Please let me know by noon Tuesday (tomorrow) if you have any questions or concerns regarding this proposed location change for structure #87 on Basin's Williston to Tioga 230 kV transmission line, Case No. PU-07-671. I am planning to issue staff approval Tuesday afternoon. Thanks.

**From:** Kevin Solie [mailto:KSolie@bepc.com]  
**Sent:** Friday, June 11, 2010 1:32 PM  
**To:** Lein, Jerry R.  
**Subject:** W-2-T Structure relocation request

58 PU-07-671 Filed: 6/15/2010 Pages: 2  
Email Staff approval of structure moves

Project Williston Area Project No. \_\_\_\_\_ Sheet 1 of \_\_\_\_\_  
 Subject Relocation Str #87 By R. Welch Date \_\_\_\_\_  
close to pipeline Ckd. \_\_\_\_\_ Rev. \_\_\_\_\_

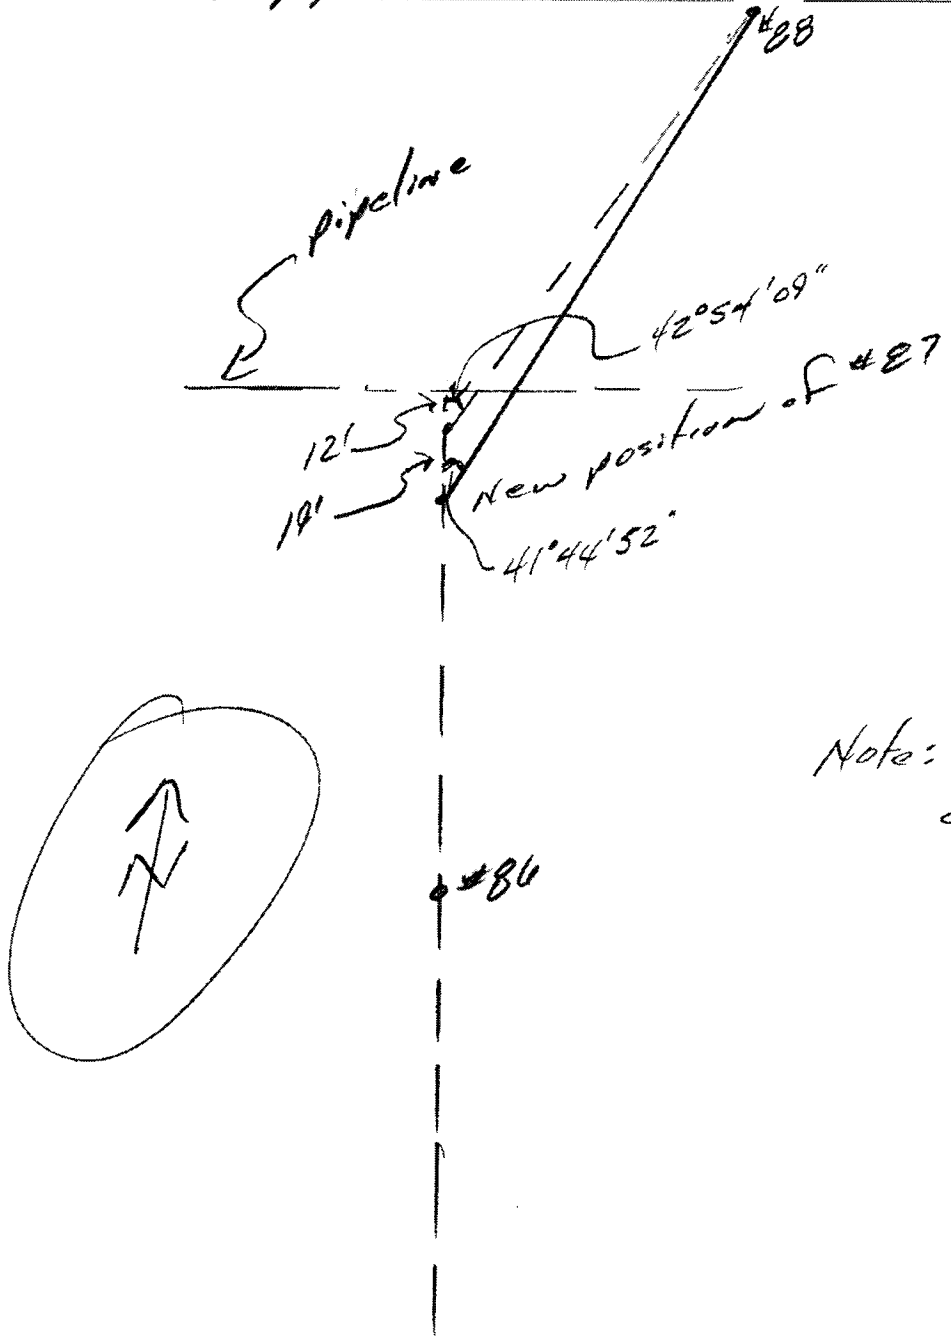
We're requesting approval relocate another structure due to a pipeline crossing. Structure #87 is currently staked 12' south of an E - W line. We propose moving it an additional 19' to the south will provide adequate clearance (31' total, while 25' is required).

Kevin - Please consider this e-mail to be staff approval of Basin Electric's requested structure location change. Thanks.
